5TH & LENORA

Recommendation Meeting #2 Summary **10**

DESIGN REVIEW RECOMMENDATION MEETING #3 - SEPTEMBER 4, 2018

OVERHEAD WEATHER PROTECTION - 3

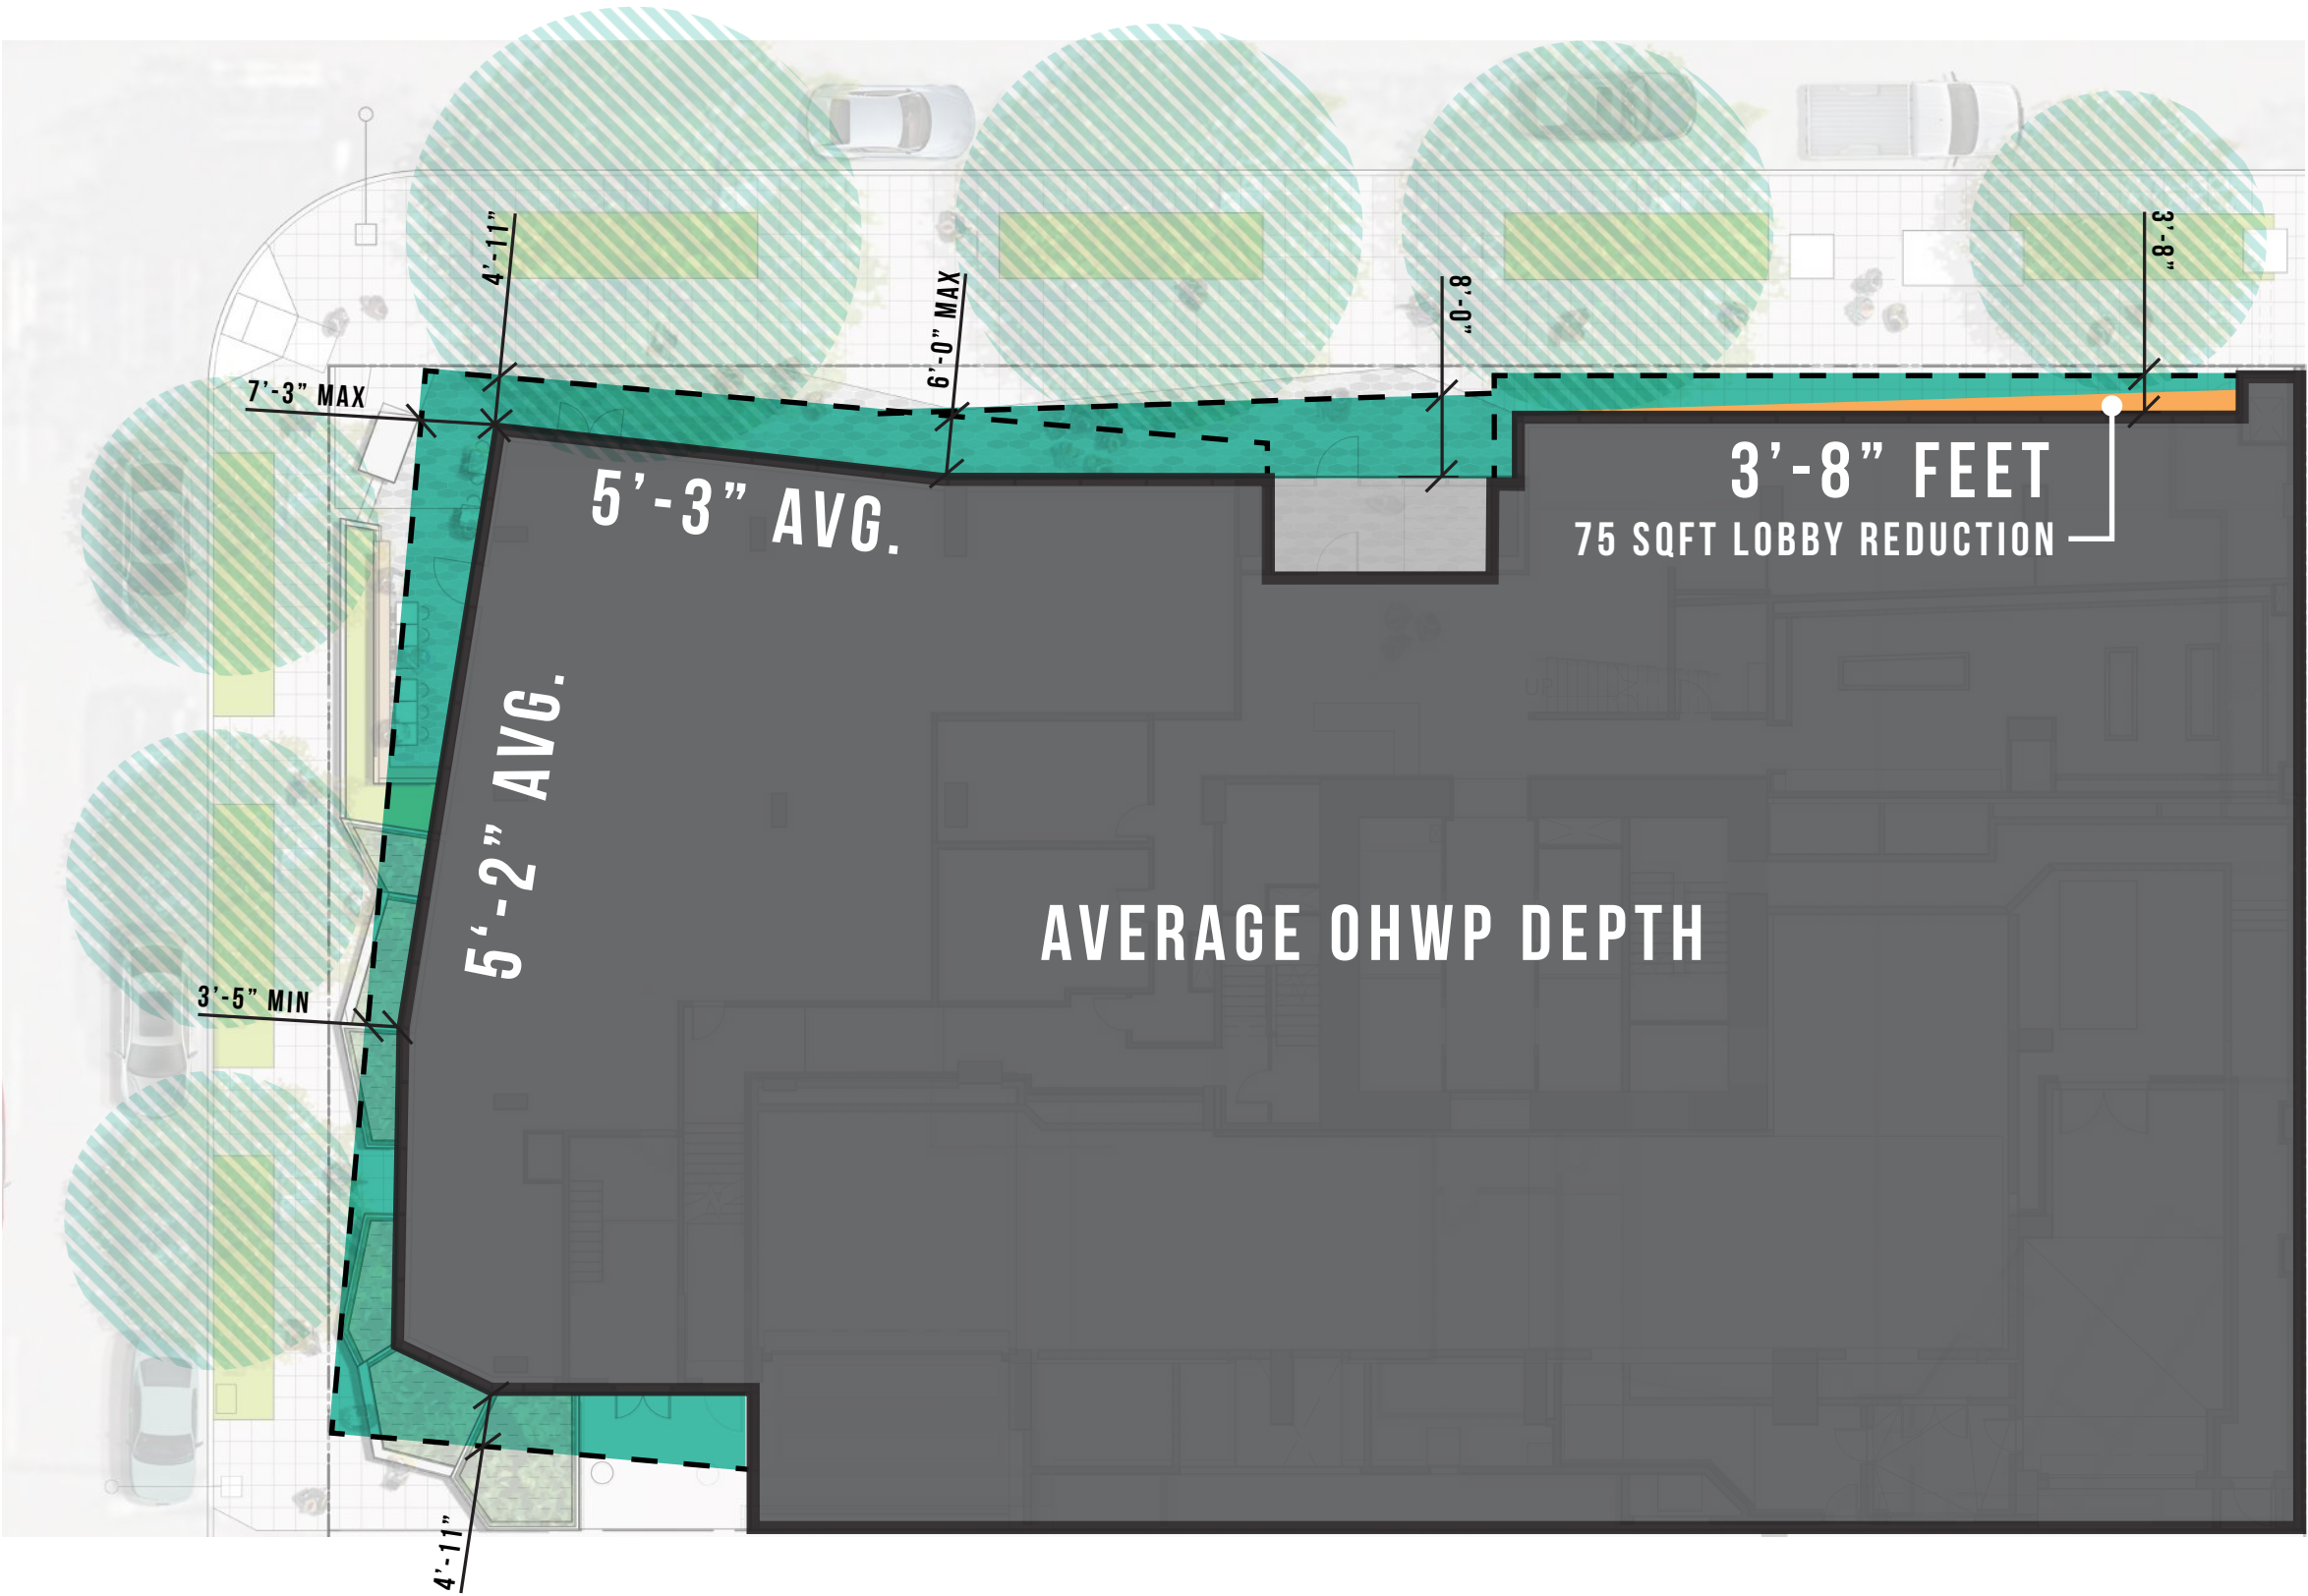
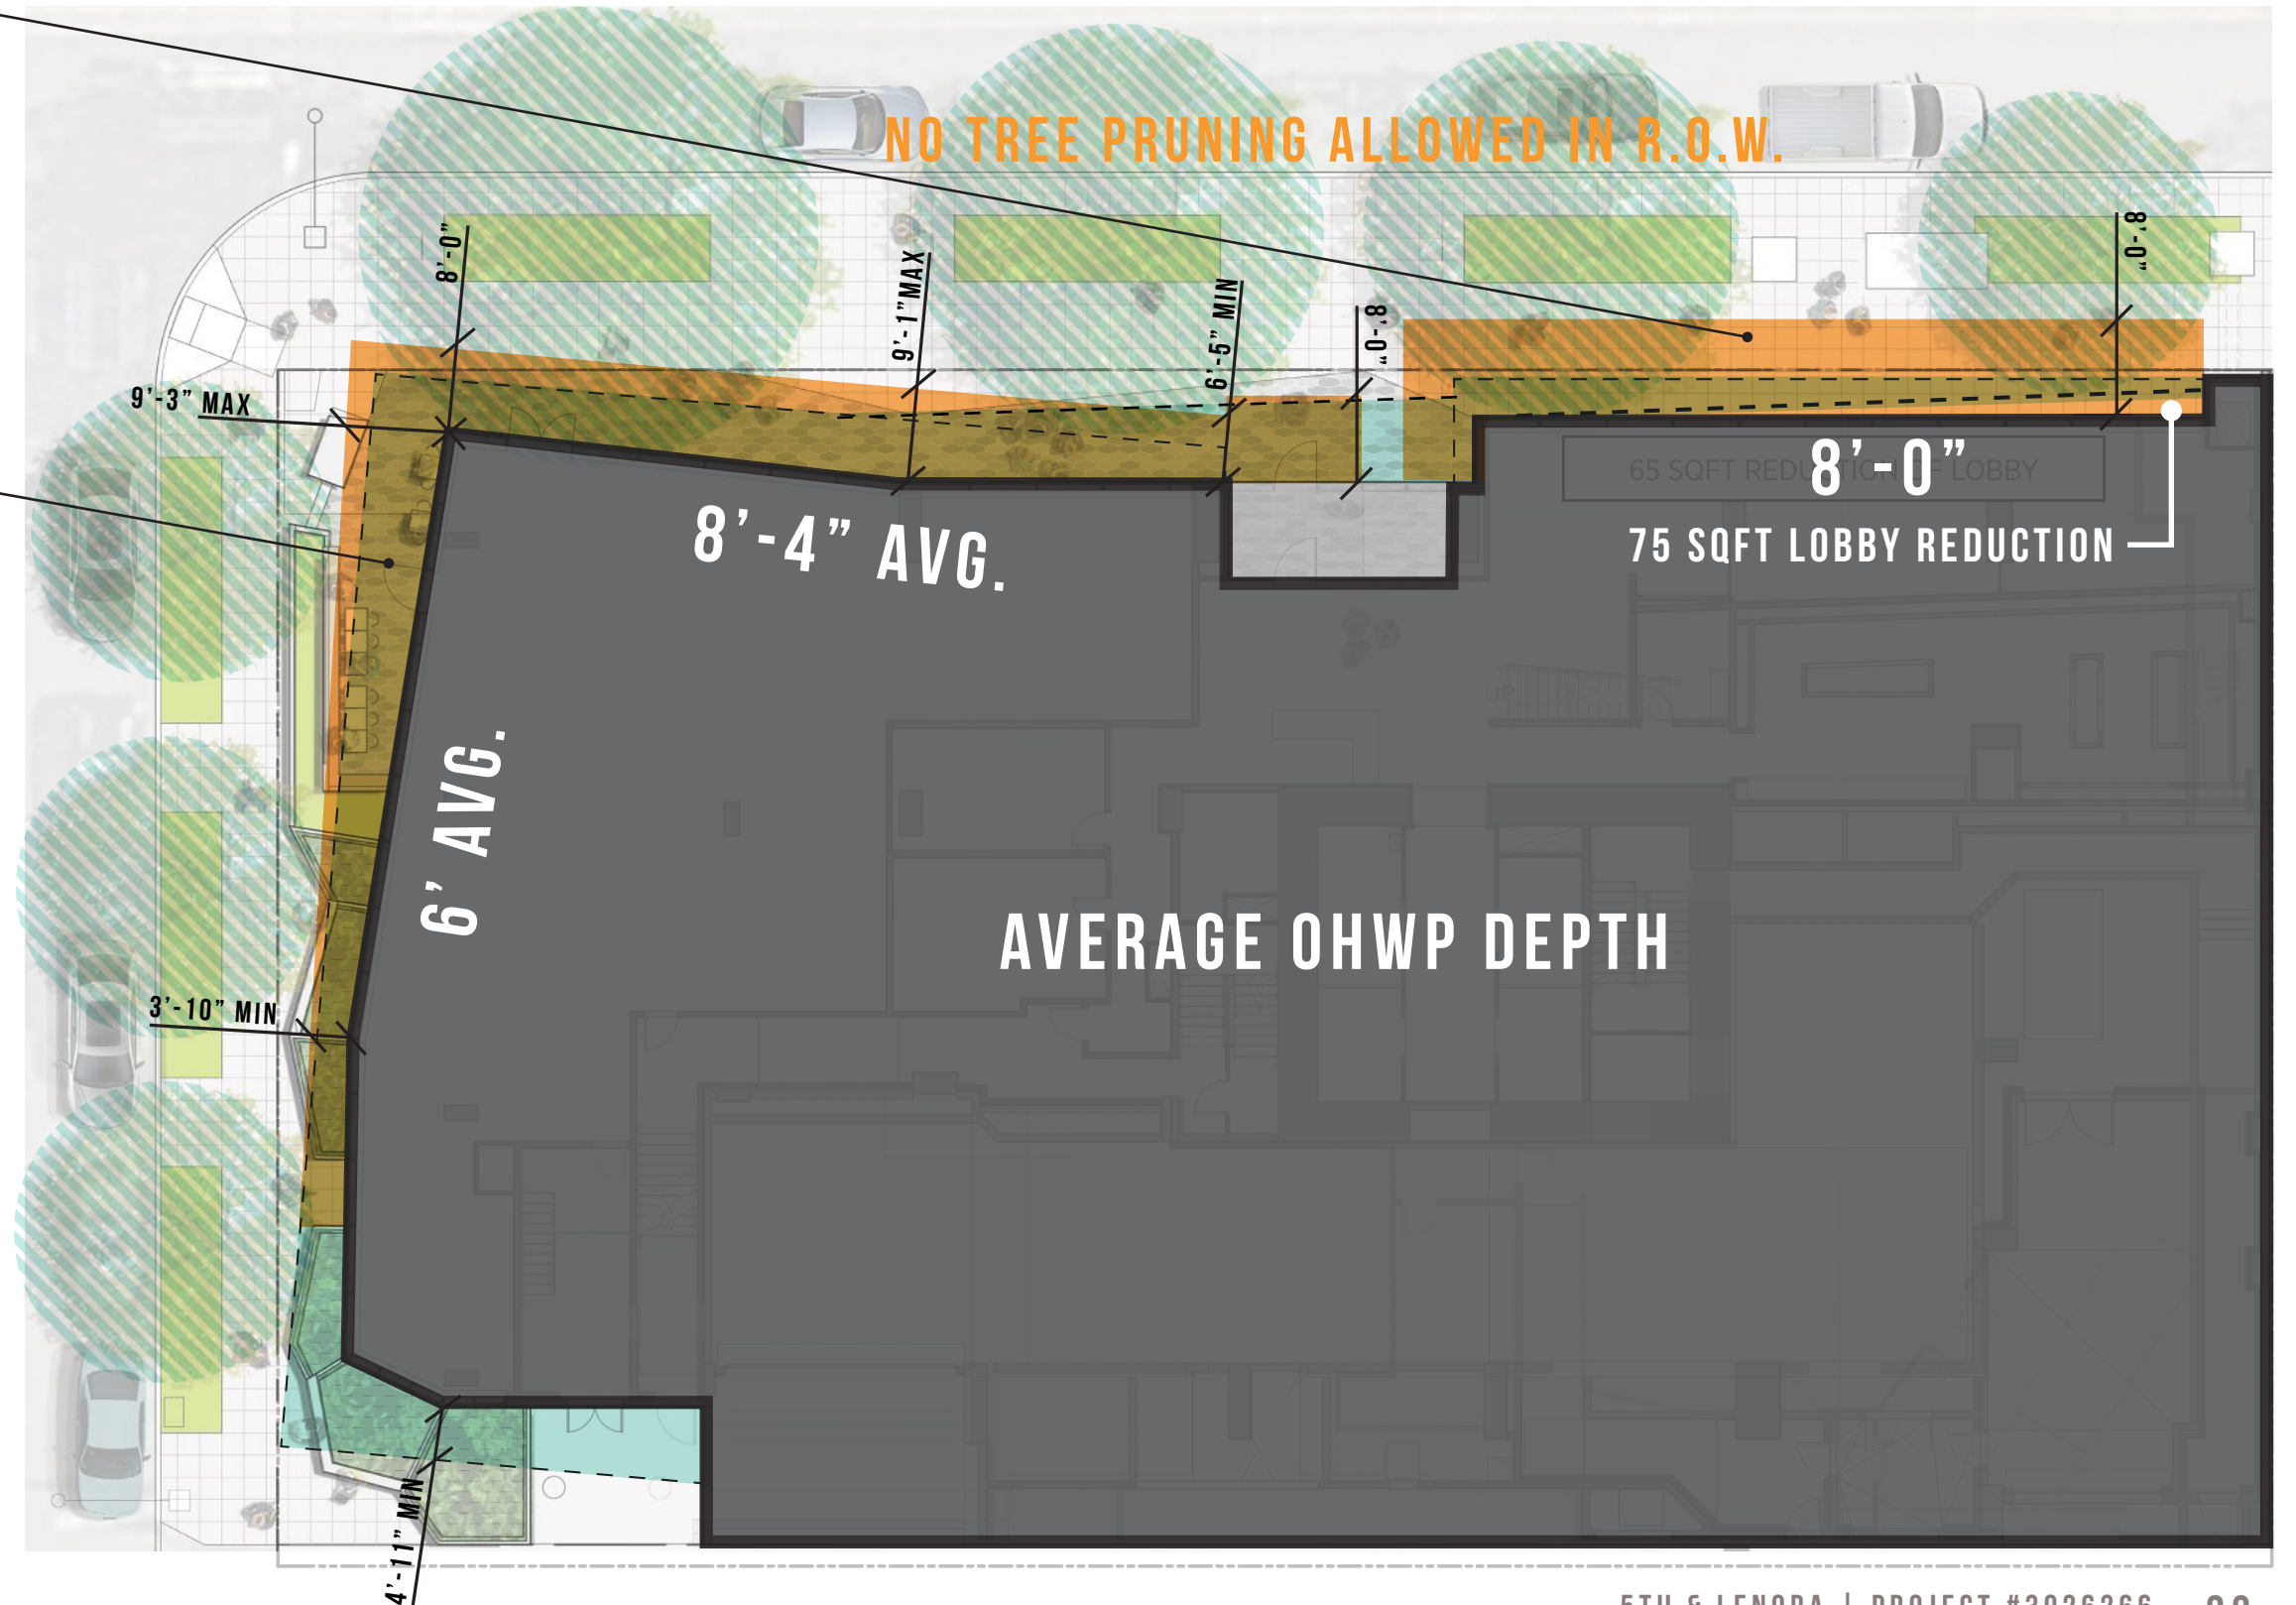
a. The Board reviewed the applicant’s suggestion for overhead weather protection. The proposal showed some building overhang at 18 feet above the walking surface next to the building in several locations. The Board, and in response to public comment, clarified that appropriate overhead weather protection (OHWP) will be about 8 to 10 feet off the walking surface (sidewalk or plaza). The Board directed the applicant to bring a design to the next meeting with overhead weather protection approximately the lower height, especially along 5th Avenue, along the face of the wall for pedestrian comfort. The OHWP may be part of an integrated entry canopy. It appears that the existing street trees will accommodate installations. Where necessary the OHWP may be modified for the tree canopy. If any planting is proposed beneath the OHWP make sure it is irrigated. (B3.3)

We have provided further clarifying information and a new design alternative for overhead weather protection with this proposal for Recommendation Meeting 3. The proposal has significant setbacks provided at sidewalk level, maintaining our expansive public environment at the street and to reduce conflicts with the existing street trees along 5th Avenue. These setbacks, combined with a few biofiltration planters, comply with zoning code requirements without any additional overhead weather protection. Significant building step overhangs above provide a substantial amount of OHWP as designed. This has been unclear in previous presentations and is quantified and illustrated for clarity in our proposal for Recommendation Meeting 3. We understand the Board’s concerns for the streetscape environment and have prepared a design alternative which adds OHWP to our existing coverage in three parts:

1) The soffit edge of the overhanging block above the retail corner is extended with a “canopy edge” similar to that being used elsewhere in the design (e.g. at the roof terrace amenity).

2) The entrance canopy has been extended to provide more coverage area at the front door.

3) A full canopy is proposed at the lobby frontage along fifth avenue, to a depth of 8 feet from the face of the building, which has been further recessed to allow this without requiring pruning of existing trees.
